The petitioner proposes to vacate Occidental Ave S between S Massachusetts St and S Holgate St in the SoDo neighborhood to facilitate development of a 750,000-square-foot, 18,000-20,000-seat multi-purpose arena for NBA basketball, NHL hockey, other sporting events, concerts, and shows.

June 18, 2015

Type Street Vacation

Phase Public Benefit

Figure 2. Plaza at the northwest corner of the site

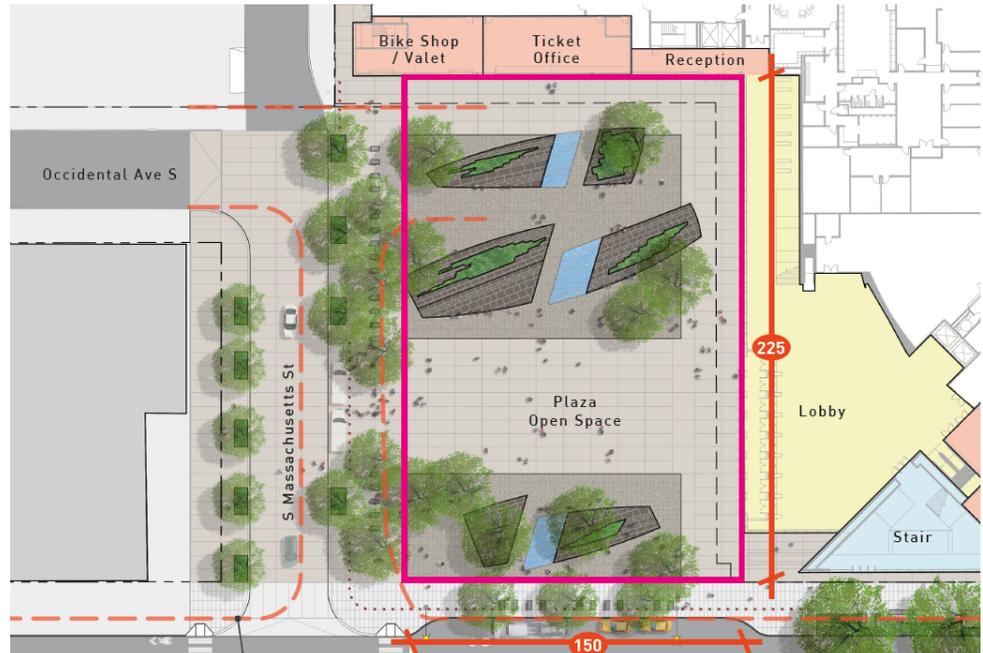
Garry Papers reminded the Commission that the project has gone through five meetings with the Downtown Design Review Board (DRB) and will have at least one more Recommendation meeting. According to Mr. Papers, the proposed plaza design as shown in the presentation materials is consistent with what the DRB saw at their last review. Mr. Papers said additional enhancements, such as seating and water features, would be logical to integrate into the next review. He recounted feedback from the DRB that the generous sidewalk and year-round club on 1st Ave S were desirable and important project elements in order to energize the sidewalk on non-event days. Lastly, Mr. Papers noted that the DRB has approximately five or six items for refinement on the plaza design.

- Develop a programming plan that emphasizes events not related to Arena function or program on non-Arena event days
- Engage a third-party entity to operate programming events.
- Endeavor to make the plaza a regional destination.
- Provide a better understanding of how the plaza design supports non-Arena events.
